GEC Project No. 1826-5010

**SUMMARY REPORT OF WETLAND EVALUATION &
REQUEST FOR DETERMINATION OF APPLICABILITY
42 MILL STREET
WESTWOOD, MASSACHUSETTS**

RE: WETLANDS/WESTWOOD
DEP File# 338-0594
42 Mill Street
**Superseding Order of
Resource Area Delineation**

Figure 8:
**GEC Revised Wetland Boundary
and Resource Area Plan**

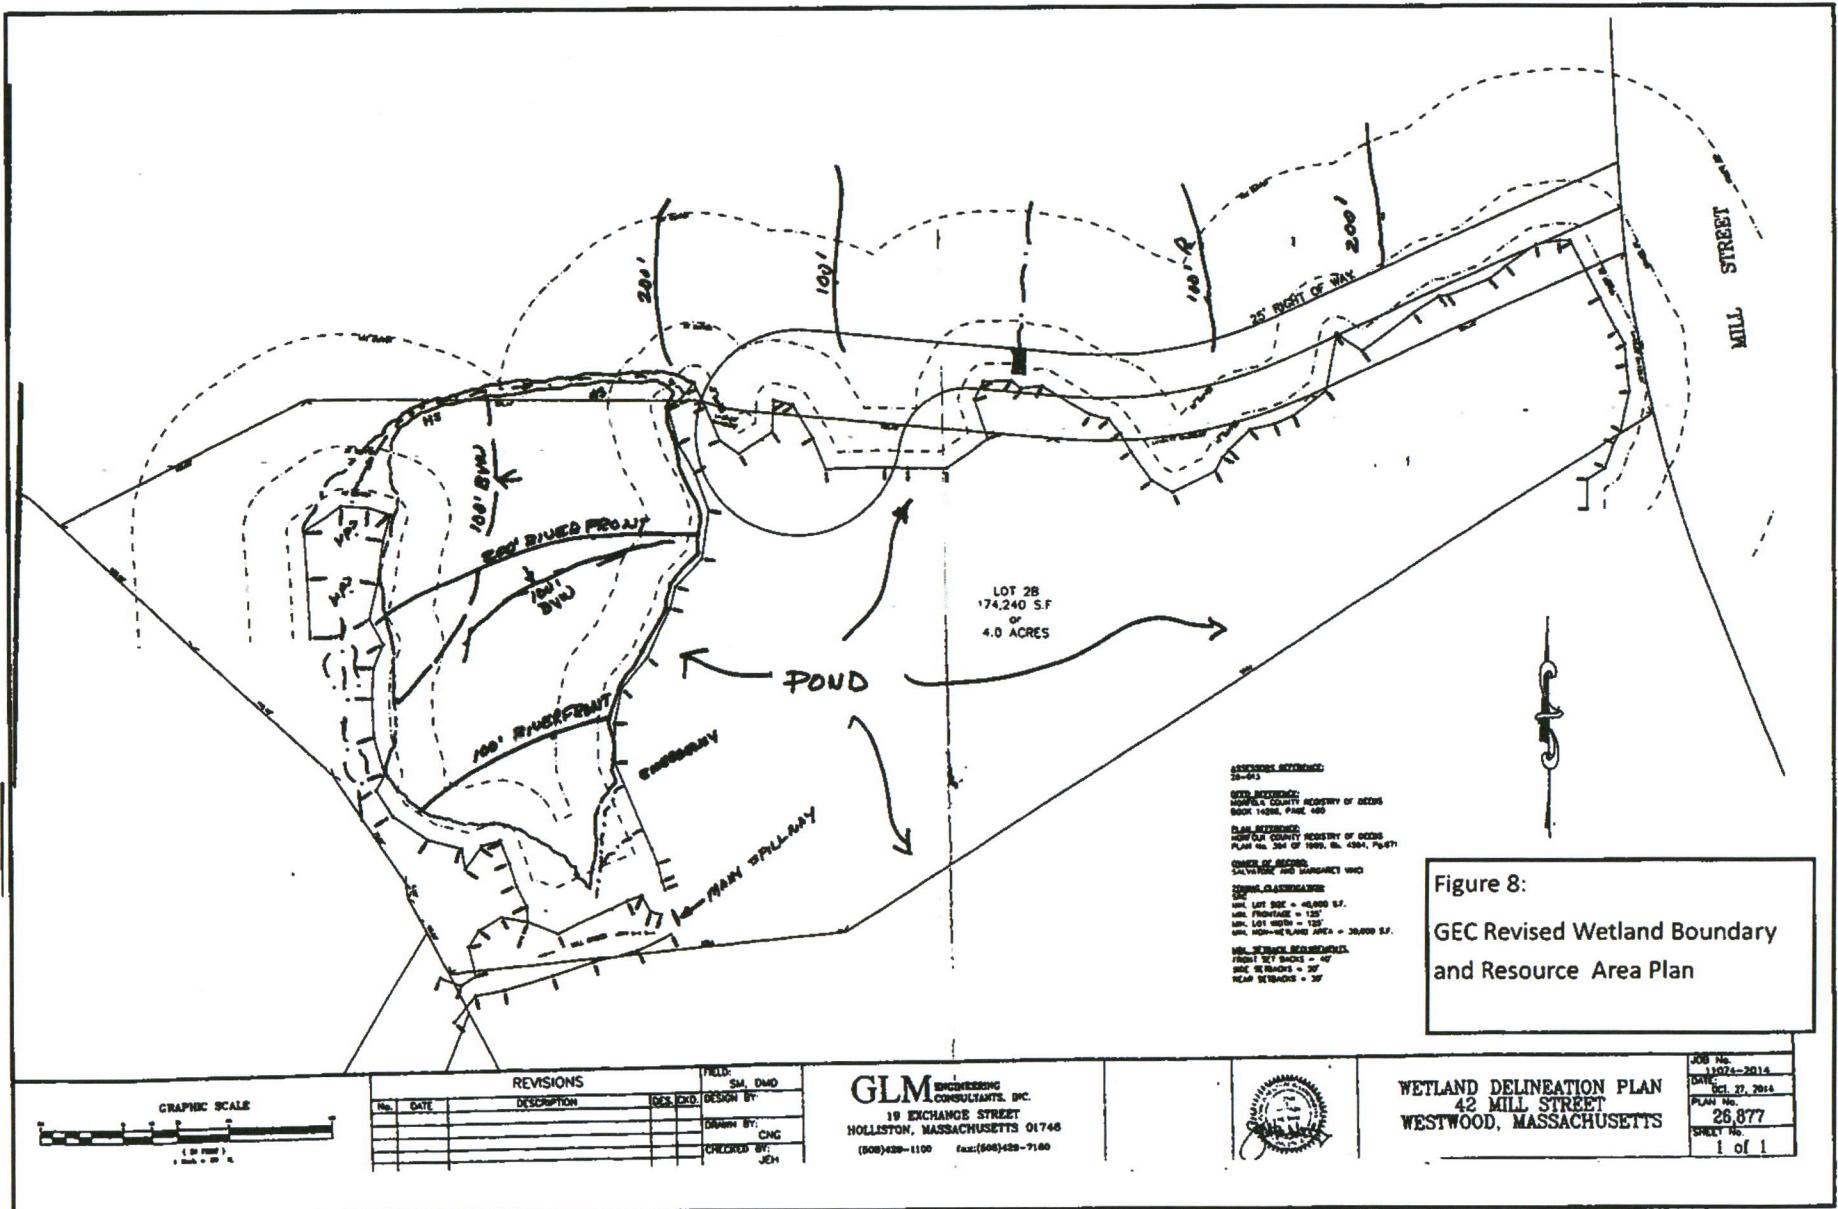
The wetlands flagging was reviewed in the field on two occasions as noted above. Generally, the applicant's base flag locations were in agreement with the review by GEC with some notable exceptions. Please refer to the GEC revised wetland plan shown as Figure 8. This plan notes the modification of the wetland boundary based on the location of the applicants flagging. Along the dam shoreline there is general agreement as well as on the far western boundary of the property. However below the dam and along the driveway GEC observed an extension of both an intermittent stream and additional streams that are part of the normal perennial stream flow through Mill Brook and the dam spillways. These extensions were supported by the identification bordering wetlands vegetation, the observance of hydric soil conditions and in the case of the stream channels below the dam of perennial characteristics. It is important to note the main stream channel below the main dam outlet was dry and the two stream channels associated with the emergency spillways were both flowing. The intermittent stream channel that runs along the driveway had hydric soil found up to a point indicated on the revised GEC plan. (See Figure 5) The wetlands vegetation comprised mostly of red maple, sweet pepperbush and ferns as well as skunk cabbage, sedges, jewelweed and rushes along the lower 140 feet of the channel. This channel shown on the revised plan by the applicant recently submitted connected to the north with the wetlands boundaries shown on the applicant plan.

Below the dam spillway, the wetland boundaries were also relocated in response to the observation of wetland vegetation mainly red maple, sweet pepperbush, northern arrowood, cinnamon fern and some royal fern. Flow from the dam emergency outlet spillway and the main stream's channel supported this wetland.

- The wetlands boundaries for the site should be modified in accordance with the revised plan submitted herein.
- The status of Mill Brook is that of a perennial stream and any development on this site should reflect the application of the rules found under the Massachusetts Rivers Protection Act regulations and the Westwood Wetlands Town bylaw, specifically the 100 and 200 foot riverfront setbacks provisions,
- The WCC should investigate the identification of two or three potential vernal pools this spring to determine if they can be certified and regulated as such,
- The existing masonry, concrete and earthen dam should be evaluated by the Town of Westwood for dam safety concerns
